Application by Waterford County Council for Waste Licence Application
W0032-03 for Dungarvan Landfill, County Waterford

Replies to Request for further information in
accordance with Article 14(2)(b)(ii) of the Waste
Management Regulations

Dungarvan Landfill Waste Licence Application Article 14 Response

Drawing Number: **MDR0350/DG0706**

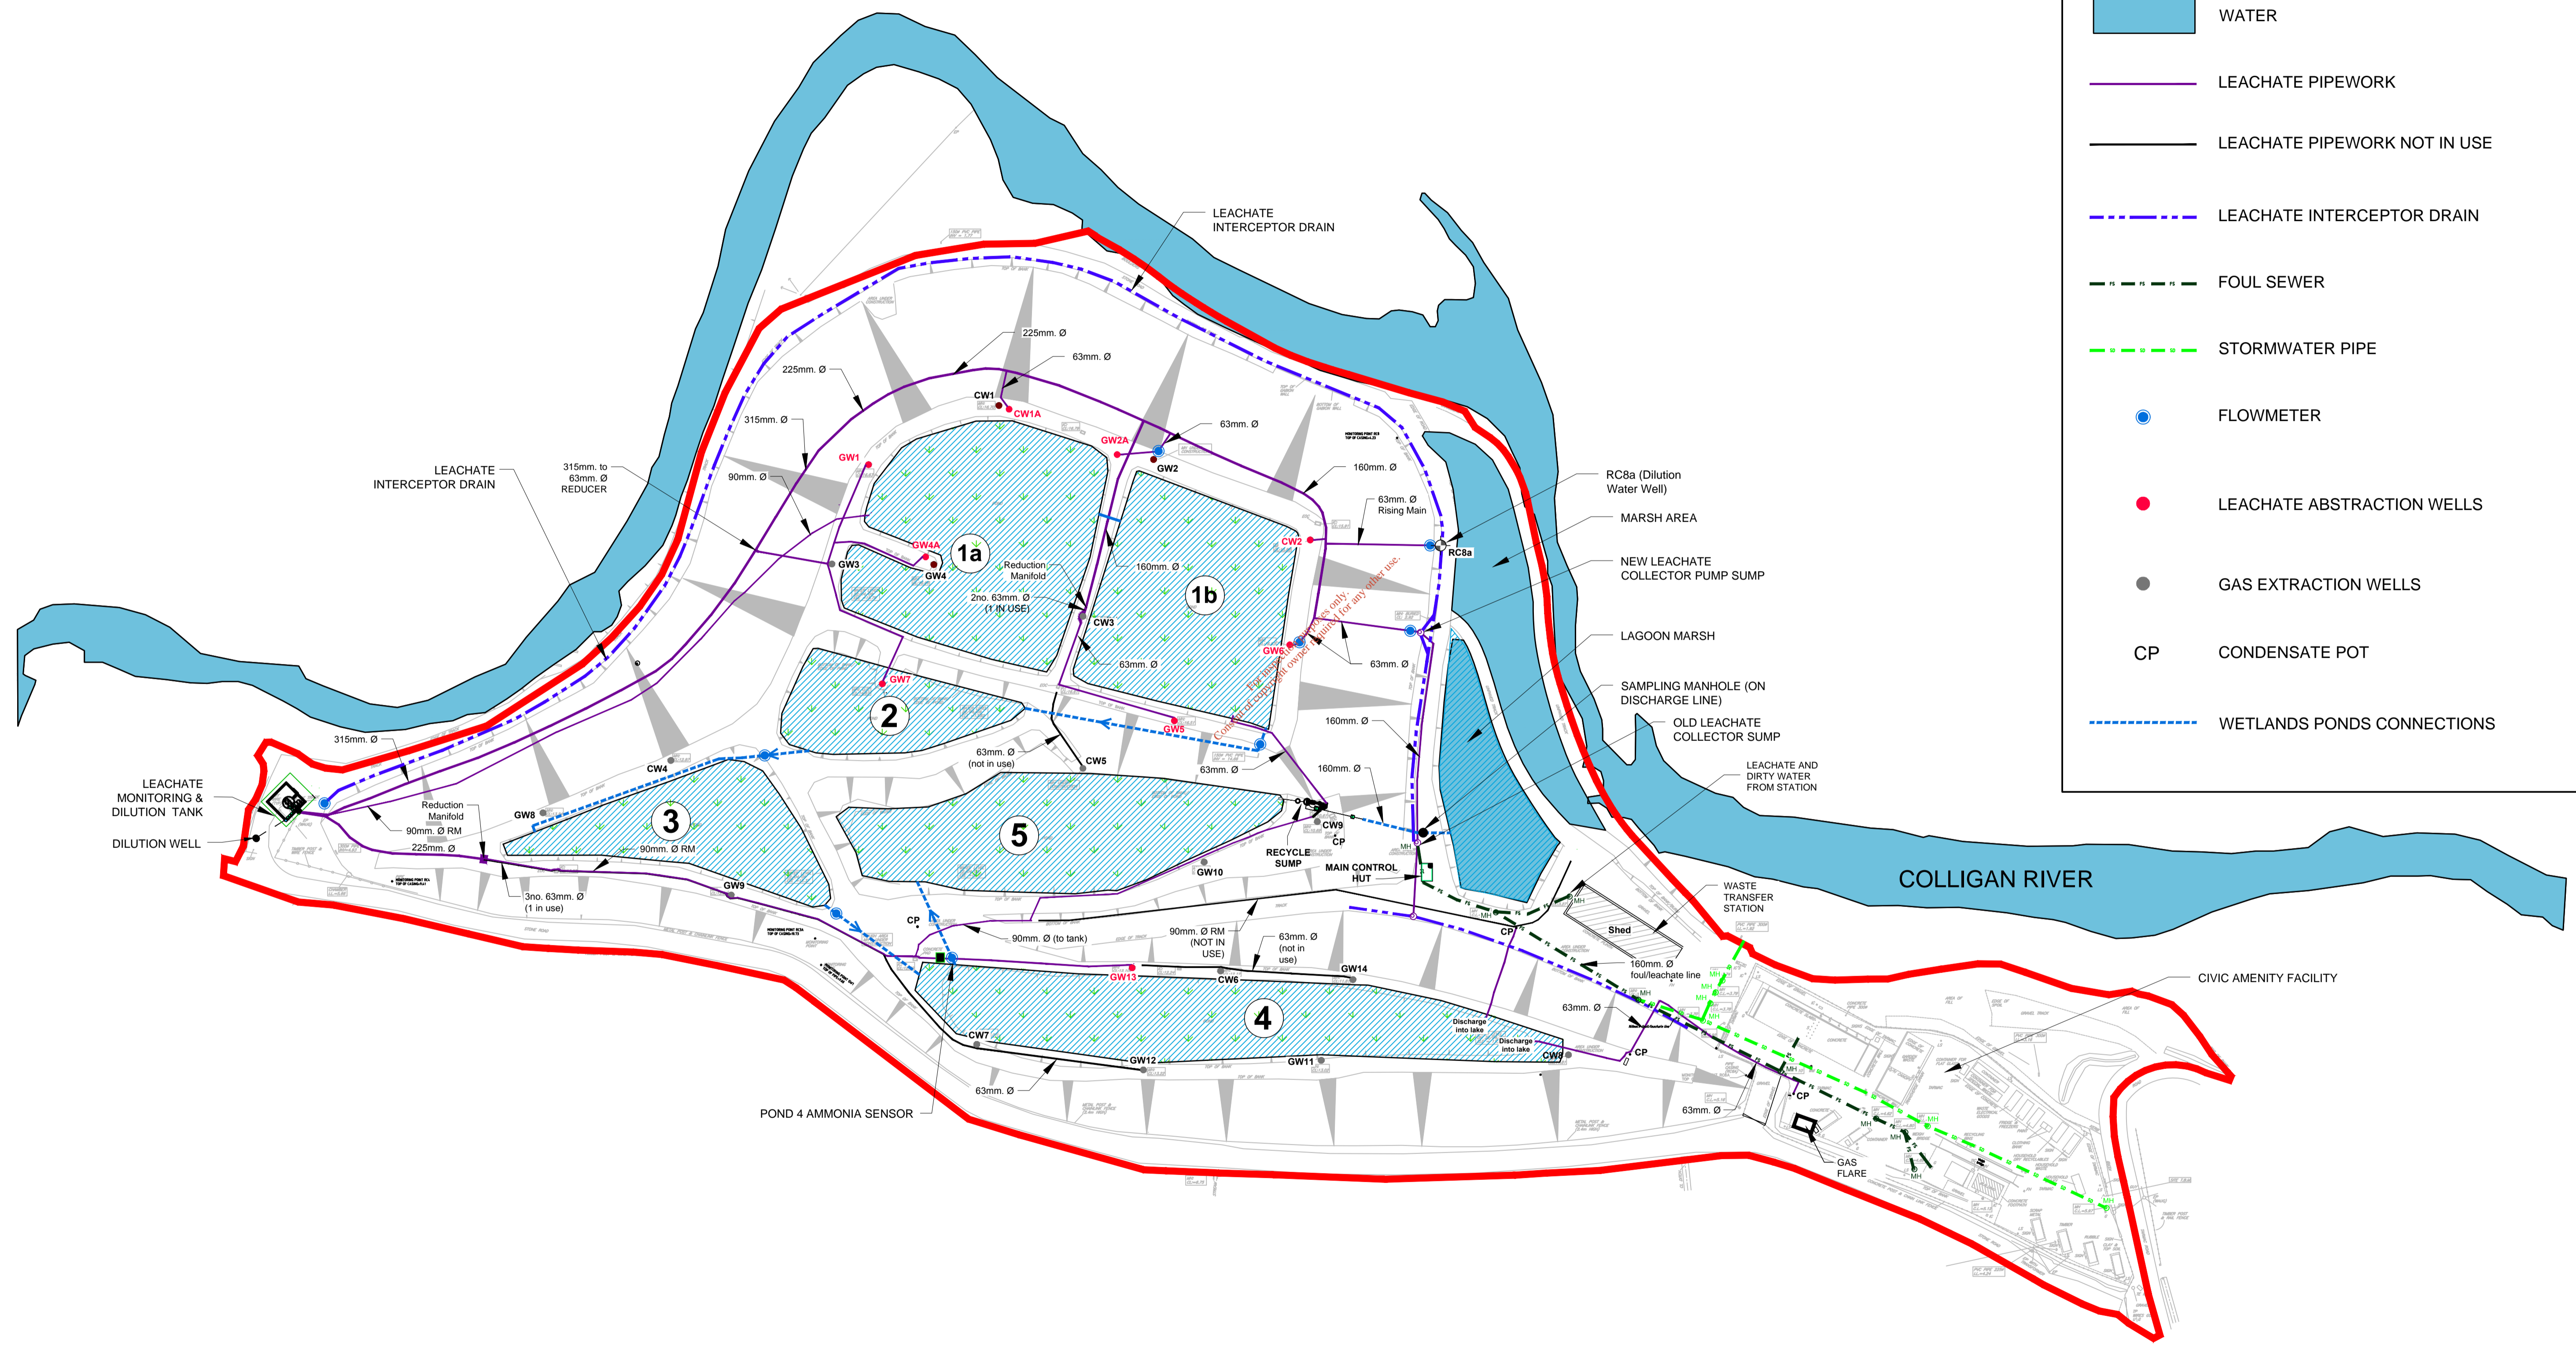
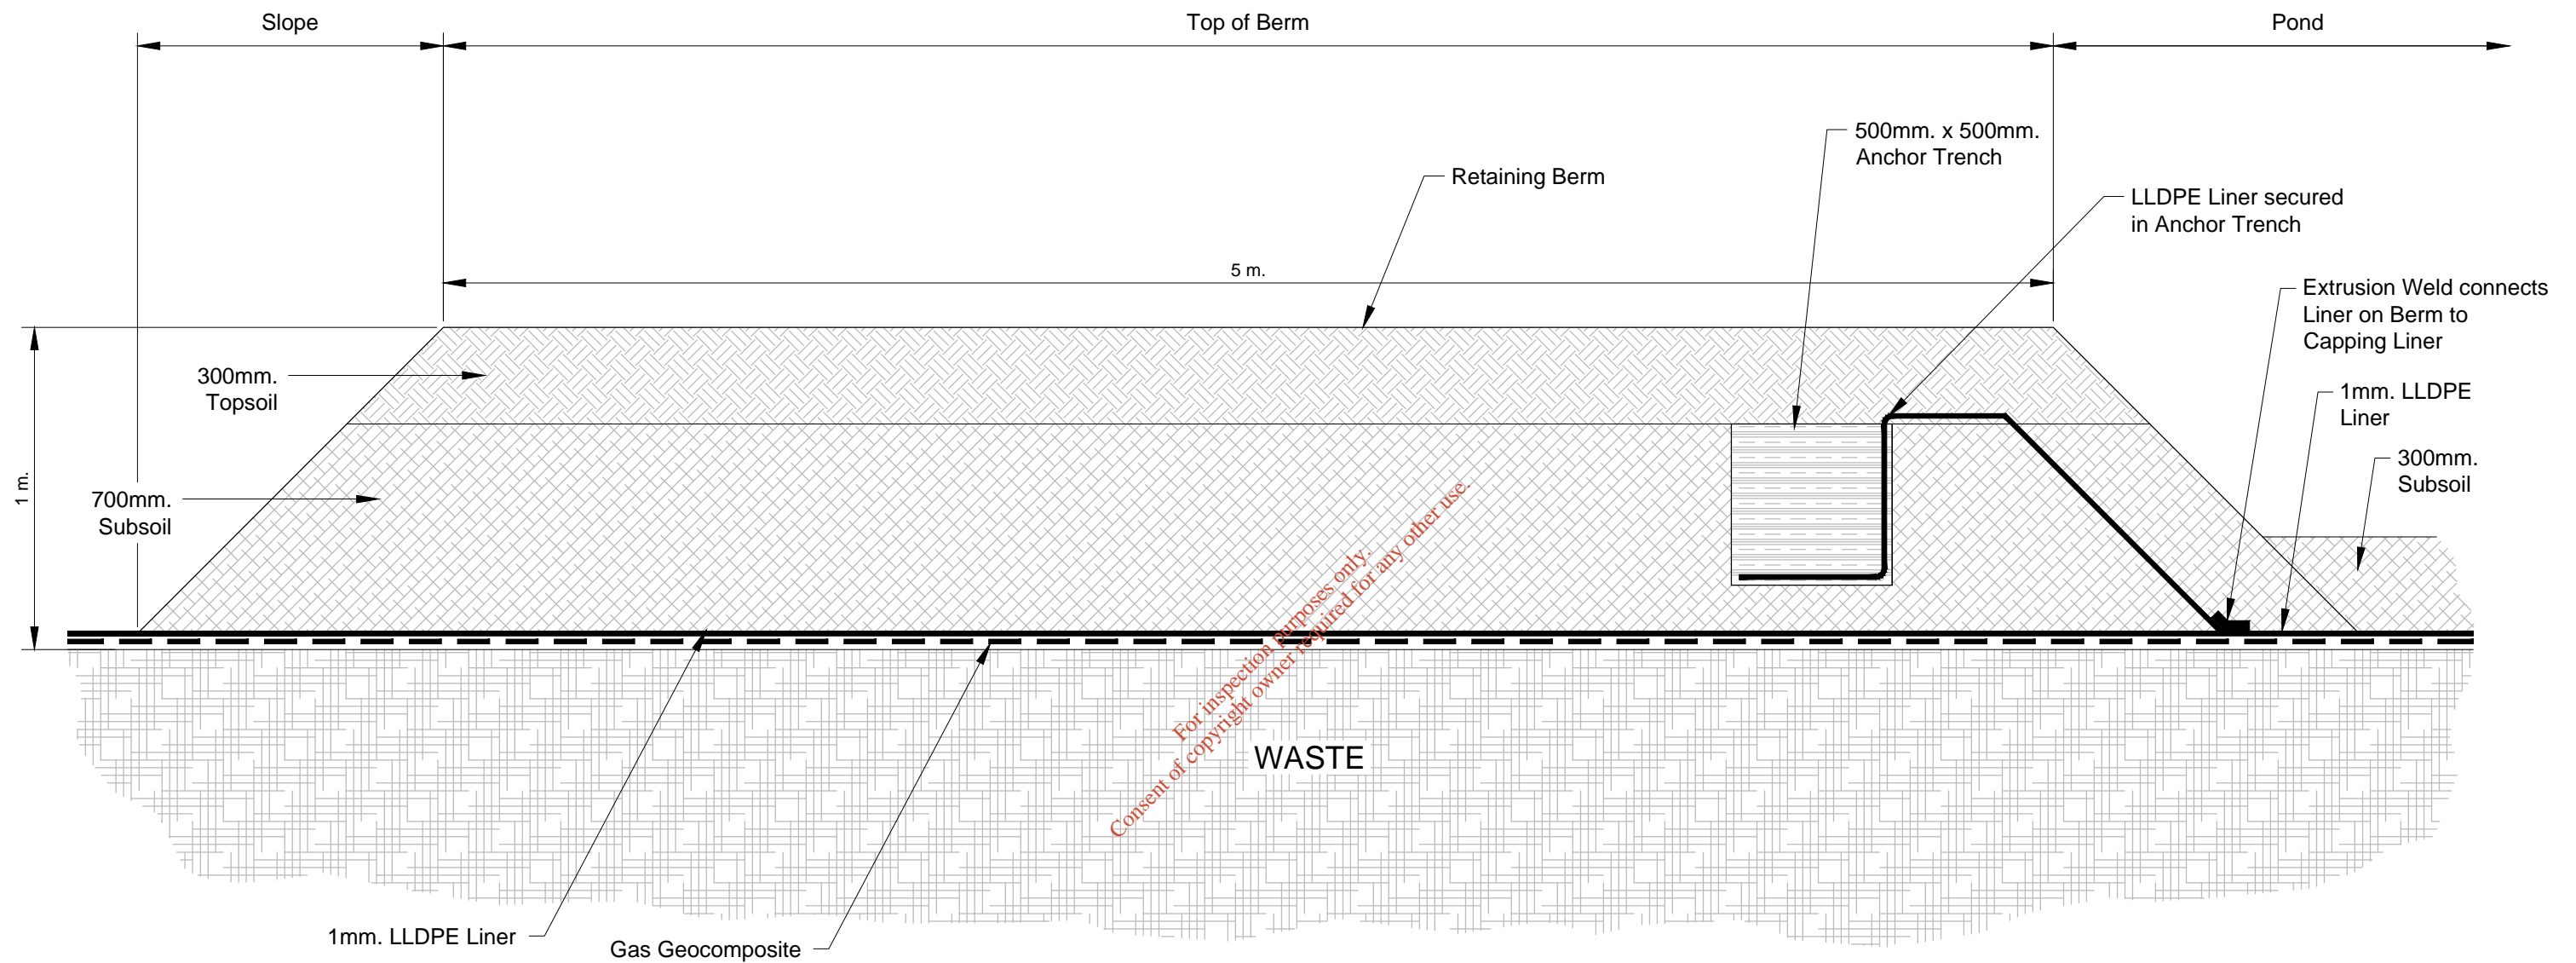
2.6.1 Response to Request

Surface water arising from the green waste reception area, composting area, and waste transfer station is collected as shown on Drawing DG0706, and discharges to the leachate collection system and into the leachate treatment system (wetland ponds) via the old leachate collector sump and new leachate collector pump sump shown. The septic tank serving the 'washing area / toilet' in the civic amenity area also connects to the leachate treatment system in this manner.

Surface water drainage from the civic reception area discharges via a 'first flush' valve and oil/petrol interceptor to the Colligan River as shown is shown on Drawing DG0706.
